DRAWN BY: D.E. WATTS DATE: 12-10-20 DWG. NO.: 20-5564-01 SURVEYED BY: DEV, ESS, 12-10-20	APPROVED BY: PROJ. NO.: DWG.:	REVISIONS:	OLIVER E. WATTS CONSULTING ENGINEER COLORADO SPRINGS	PROJECT: 16810 SOUTH PEYTON HIGHWAY PART NE S8, T.17S., R.63W., 6TH P.M. EL PASO COUNTY, COLORADO	SHEET NAME: SITE PLAN	SHEET NO.: 1 OF 1
---	-------------------------------------	------------	--	--	---------------------------------	----------------------------

Landscape Plan_V1.pdf Markup Summary

DETAILED PLAN $\Rightarrow \Rightarrow \Rightarrow$
1"=40'

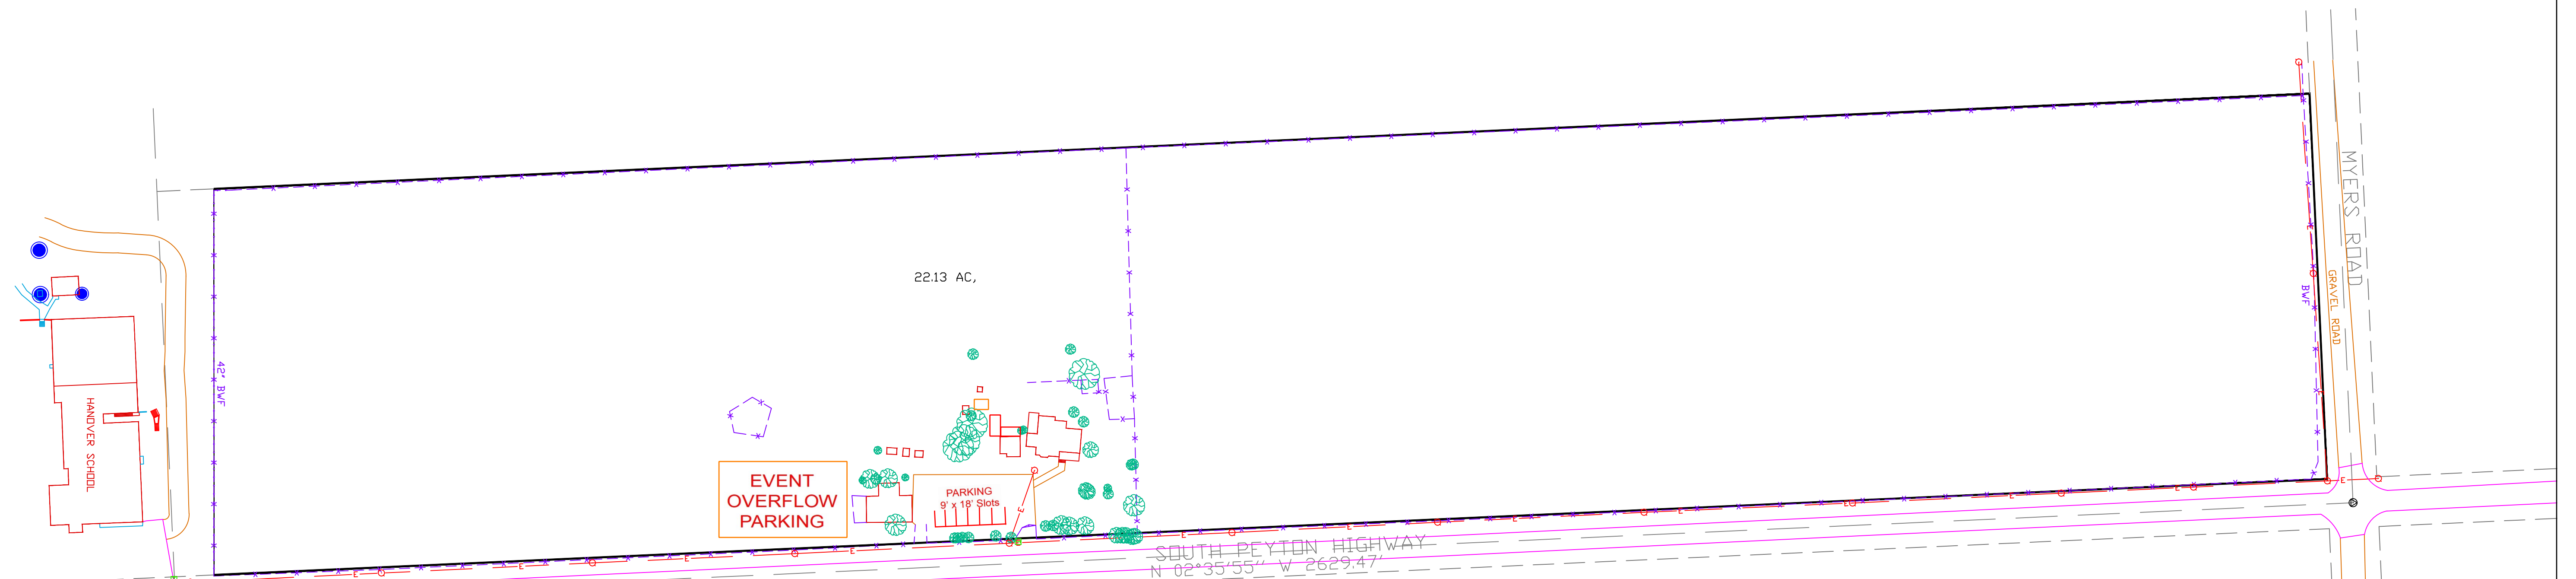
Landscape Requirements in Ch. 6 apply per the Applicability subsection and are not being met. I have attached the landscape requirements from the Code within the EDARP comments, please refer to them and revise the landscape plan accordingly.

Alternatively, if landscape requirements in Chapter 6 (attached to comment provided in EDARP) will not be met, then please request an alternative landscape plan in the letter of intent and justify it by explaining how the proposed landscaping meets the purpose of the code and promotes the concepts contained in the Landscape and Water Conservation Manual.
